## **REPORT FOR ACTION**

## **119 Harewood Avenue, Committee of Adjustment Application**

Date: November 24, 2017
To: Chair and Committee Members of the Committee of Adjustment, Scarborough Panel
From: Director, Community Planning, Scarborough District
Wards: 36
File Number: B0051/17SC, A0355/17SC, A0356/17SC
Hearing Date: December 7, 2017

#### Figure 2: Site Plan

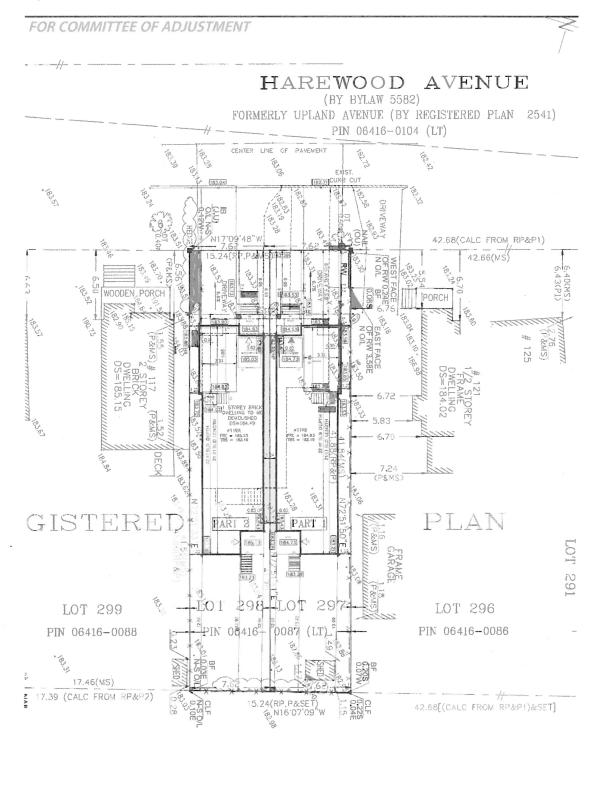
This application is for consent to sever the property into two lots. Part 1 would have a frontage of 7.62 m and a lot area of 318.25 m<sup>2</sup>. Part 2 would have a frontage of 7.62 m and a lot area of 317.1 m<sup>2</sup>. The proposed lots are shown on the Draft Reference Plan (see Figure 1: Draft Reference Plan). The applicant is proposing to demolish the existing house and build two new detached houses (see Figure 2: Site Plan). The following variances are being requested:

- The proposed south side yard setback is 0.62 m Whereas the minimum required side yard setback is 0.9 m
- The proposed floor area is 342.62 m<sup>2</sup> or 1.08 times the lot area (the basement level is deemed the first floor and is included in the floor area)
   Whereas the maximum permitted floor area is 190.31 m<sup>2</sup> or 0.6 times the lot area.
- The proposed lot area is 318.25 m<sup>2</sup>
   Whereas the minimum required lot area is 464 m<sup>2</sup>
- 4. The proposed lot frontage is 7.62 m Whereas the minimum required lot frontage is 12 m
- 5. The proposed lot coverage is 40.8% Whereas the maximum permitted lot coverage is 33%

- 6. The proposed main wall height is 7.03 m Whereas the maximum permitted main wall height is 7 m
- 7. The proposed dwelling is 3 storeys Whereas the maximum permitted number of storeys is 2

- The proposed height of the first floor above established grade is 1.34 m Whereas the maximum permitted height of the first floor above established grade is 1.2 m

- The proposed building length is 21.61 m, measured from the front wall to the rear wall
   Whereas the maximum permitted building length is 17 m
- 10. The proposed building depth is 22.7 m, measured from the front yard setback requirement on a lot to the rear wall Whereas the maximum permitted building depth is 19 m

- 11. The proposed eaves would project 0.43 m and would be located 0.2 m from the south lot line Whereas the eaves of a roof may encroach into a required minimum building setback a maximum of 0.9 m, if they are no closer to a lot line than 0.3 m

- 1. The proposed north side yard setback is 0.62 m Whereas the minimum required side yard setback is 0.9 m
- The proposed 324.7 m<sup>2</sup> floor area or 1.02 times the lot area (the basement level is deemed the first floor and is included in the floor area)
   Whereas the maximum permitted floor area is 190.31 m<sup>2</sup> or 0.6 times the lot area
- 3. The proposed lot area is 317.1 m<sup>2</sup> Whereas the minimum required lot area is 464 m<sup>2</sup>
- 4. The proposed lot frontage is 7.62 m Whereas the minimum required lot frontage is 12 m
- 5. The proposed lot coverage is 39.3% Whereas the maximum permitted lot coverage is 33%
- 6. The proposed main wall height is 7.11 m Whereas the maximum permitted main wall height is 7 m
- The proposed dwelling is 3 storeysWhereas the maximum permitted number of storeys is 2

- The proposed height of the first floor above established grade is 1.4 m Whereas the maximum permitted height of the first floor above established grade is 1.2 m
- The proposed building length is 21.61 m, measured from the front wall to the rear wall
   Whereas the maximum permitted building length is 17 m
- The proposed building depth is 22.7 m, measured from the front yard setback requirement on a lot to the rear wall Whereas the maximum permitted building depth is 19 m
- 11. The proposed eaves would project 0.43 m and would be located 0.2 m from the south lot line Whereas the eaves of a roof may encroach into a required minimum building setback a maximum of 0.9 m, if they are no closer to a lot line than 0.3 m

Community Planning staff recommend that the applications be **refused** to protect the neighbourhood's prevailing pattern of lot frontages and existing physical character.
